OMRON

Product Discontinuation Notices

No.2009192E

Discontinuation Notice of H5CX Series due to renewal

Front Design

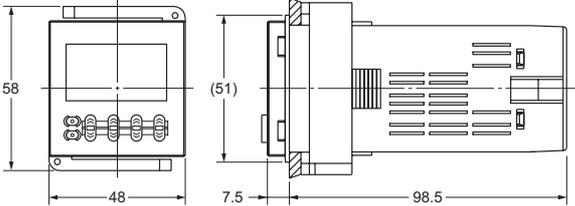
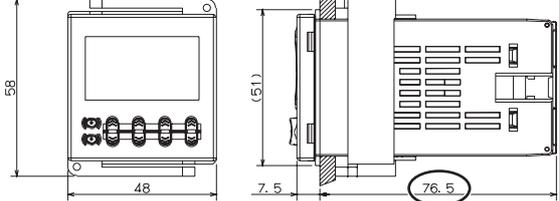
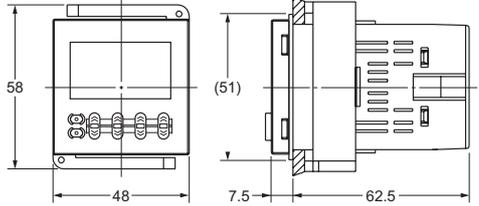
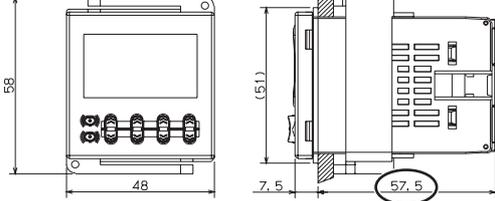
<Front>
   Flat display around LCD area.
   Display the RST, K/P, OUT in the front panel.

<LCD Display>
   Character height of present value: 11.5mm
   Use single light to indicate the function of RST, K/P, OUT

<Front>
	   Rounded 3D display around LCD area.
	   Deletion of the RST, K/P, OUT display.

<LCD Display>
	   Character height of present value: 12mm
	   Deletion of single light display and add RST, Key logo, RST in the LCD. (a)
	   Addition of segment (line) in the displayed number. (b)

| Product discontinuation Model H5CX-BWSD	Recommendable replacement Model H5CX-BWSD-N

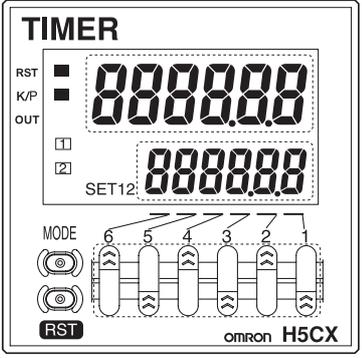
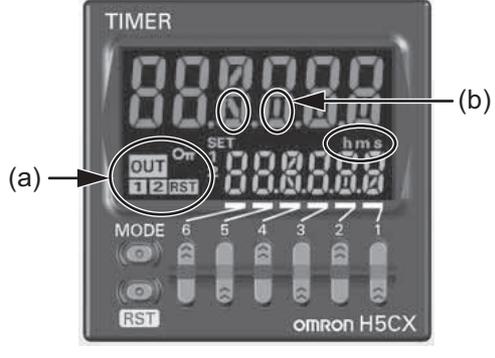
<Front>
   Flat display around LCD area.
   Display the RST, K/P, OUT in the front panel.

<LCD Display>
   Character height of present value: 9mm
   Use single light to indicate the function of RST, K/P, OUT.

<Front>
	   Rounded 3D display around LCD area.
	   Deletion of the RST, K/P, OUT display.

<LCD Display>
	   Character height of present value: 10mm
	   Deletion of single light display and add RST, Key logo, OUT, h, m, s in the LCD. (a)
	   Addition of segment (line) in the displayed number. (b)

Colors

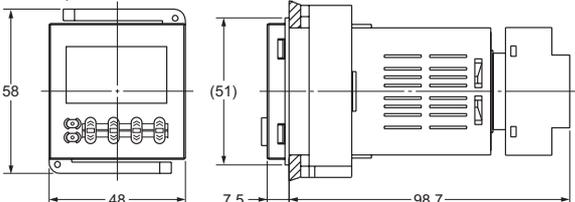
Product discontinuation Model H5CX-[] Series	Recommendable replacement Model H5CX-[]-N Series
Key-protect switch: Light grey 	Key-protect switch: Silver

Mounting Dimensions

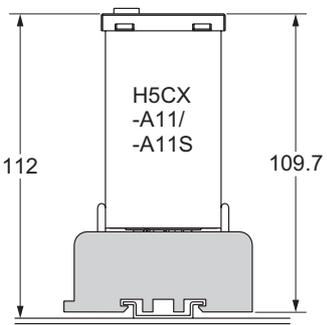
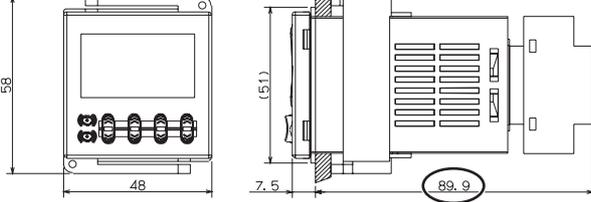
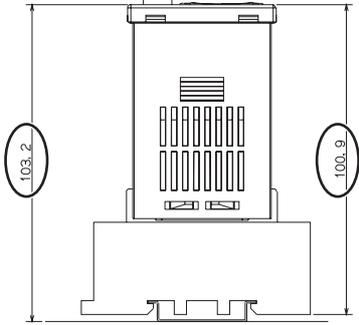
Product discontinuation Model H5CX-A/-AS	Recommendable replacement Model H5CX-A/-AS -N
Terminal Block Type (Flush Mounting Models)	
58, (51), 48, 7.5, 98.5	58, (51), 48, 7.5, 76.5 — Depth of 76.5mm.

Product discontinuation Model H5CX-AD/-ASD/-BWSD	Recommendable replacement Model H5CX-AD/-ASD/-BWSD -N
Terminal Block Type (Flush Mounting Models)	
58, (51), 48, 7.5, 62.5	58, (51), 48, 7.5, 57.5 — Depth of 57.5mm.

Product discontinuation Model H5CX-A11/-A11S	Recommendable replacement Model H5CX-A11/-A11S -N
Socket Type (Flush Mounting/Surface Mounting Models)	
58, (51), 48, 7.5, 98.7	58, (51), 48, 7.5, 89.9 — Depth of 89.9mm.
H5CX -A11/ -A11S, 112, 109.7, P2CF-11, P2CF-11-E	103.2, 100.9 — Mounting dimensions is 100.9mm and 103.2mm.

| Product discontinuation Model H5CX-[] Series	Recommendable replacement Model H5CX-[]-N Series

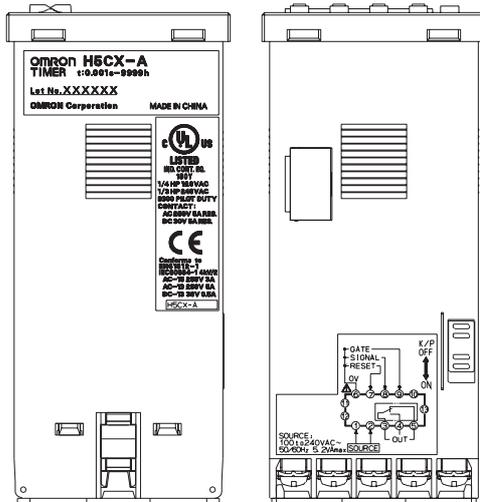
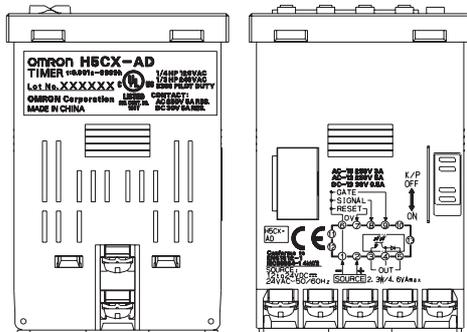
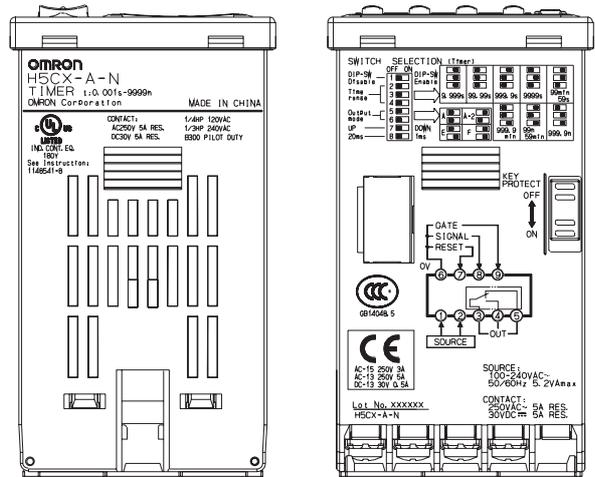
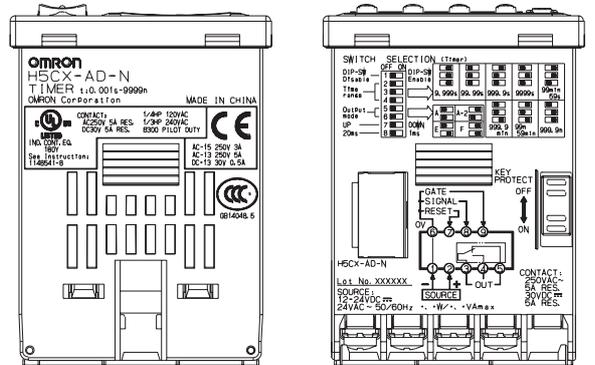
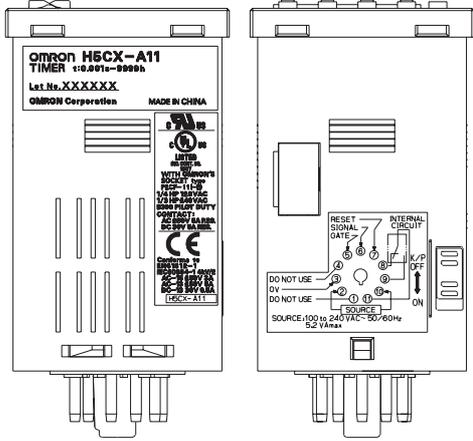
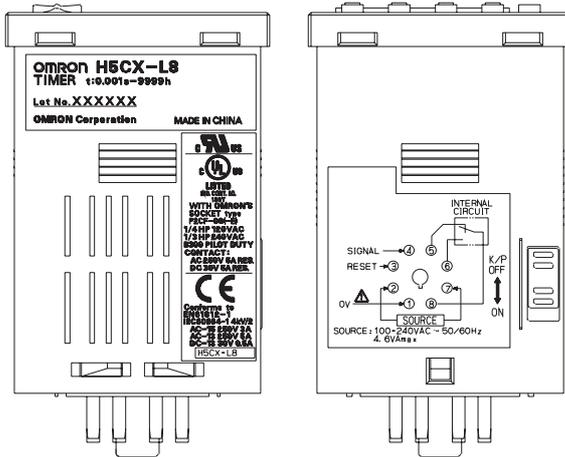
Body Label
Sticker on top and right side of the product.

Lot No.: Production year of last digit
    e.g. [] [] [] [] []
       (1) (2) (3) (4) (5)

(1),(2) Production Day: 01-31
(3)   Production Month: 1 to 9, X,Y,Z
              X = 10, Y = 11, Z = 12
(4)   Production Year: Last digit of the year
(5)   Abbreviation code for Production Factory
	Print directly with the laser on the top and right side of the product.

Lot No.: Production year of last two digits
	    e.g. [] [] [] [] [] []
	       (1) (2) (3) (4) (5) (6)

(1),(2) Production Day: 01-31
	(3) Production Month: 1 to 9, X,Y,Z
	              X = 10, Y = 11, Z = 12
	(4),(5) Production Year: Last two digits of the year
	(6) Abbreviation code for Production Factory

Labels

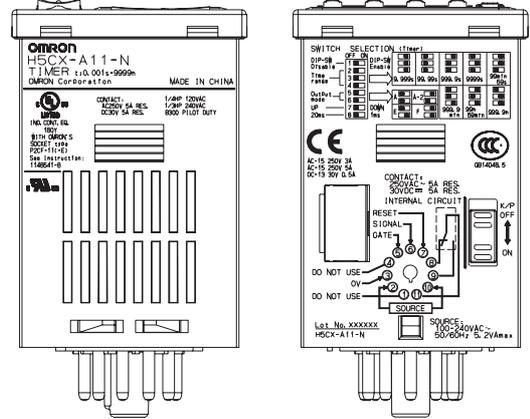
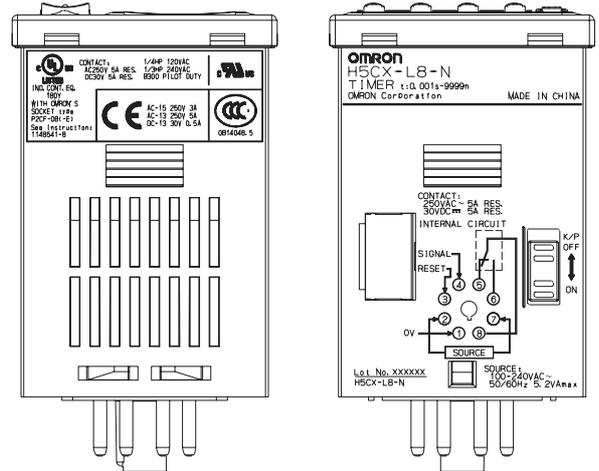
Other label changes are followings (printing idea):

Marking of CCC standard will become in August after acquisition. Model H5CX-[]-N Series (except the model with SD)

Labels

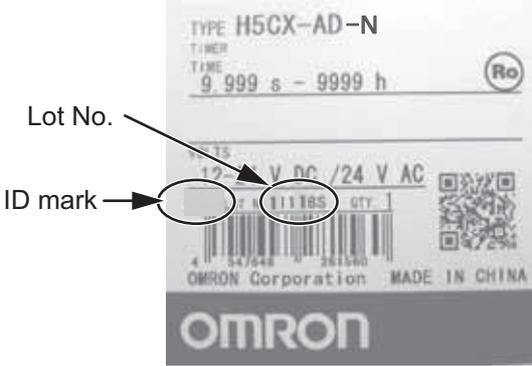
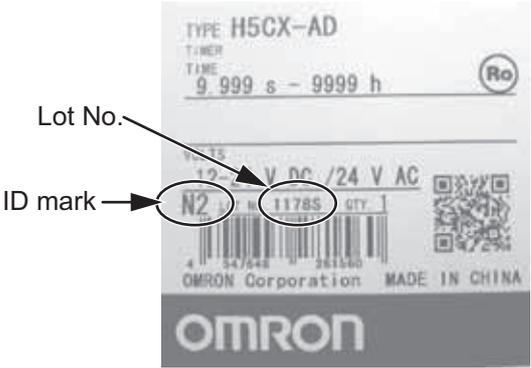
Packing label
  Lot No.: Production year of last digit
      e.g. [] []   []   [] []
          (1) (2) (3) (4) (5)

(1),(2) Production Day: 01-31
(3)   Production Month: 1 to 9, X,Y,Z
                X = 10, Y = 11, Z = 12
(4)   Production Year: Last digit of the year
(5)   Abbreviation code for Production Factory

ID mark: Either none or N2 depend on the model.
	Lot No.: Production year of last two digits
	      e.g. [] [] [] [] [] []
	          (1) (2) (3) (4) (5) (6)

(1),(2) Production Day: 01-31
	(3) Production Month: 1 to 9, X,Y,Z
	                X = 10, Y = 11, Z = 12
	(4),(5) Production Year: Last two digits of the year
	(6) Abbreviation code for Production Factory

ID mark: None
	 2D QR code: Changed due to an adoption of a
	              new product code.
	 EAN code: Changed due to an adoption of a new
	           product code.
